B. Responses to Comment Letters

Comment Letter L17
City of Yorba Linda
February 3, 2014

**Response to
Comment Letter L17
City of Yorba Linda
February 3, 2014**

Exhibit A – Four PYUSD Schools Near the Proposed Esperanza Hills Project

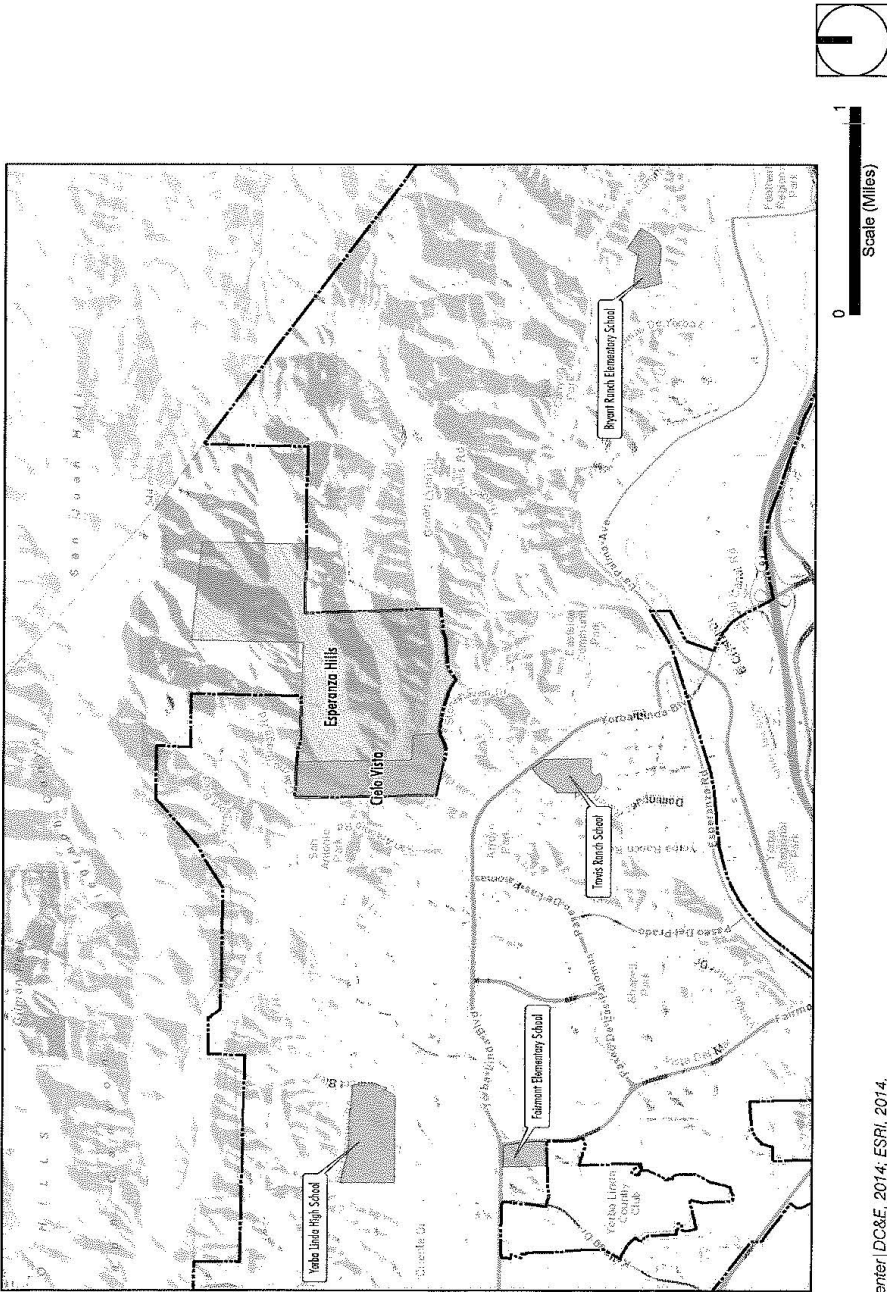
L20-15 All environmental impacts have been adequately addressed in the DEIR. Therefore, recirculation is not required.
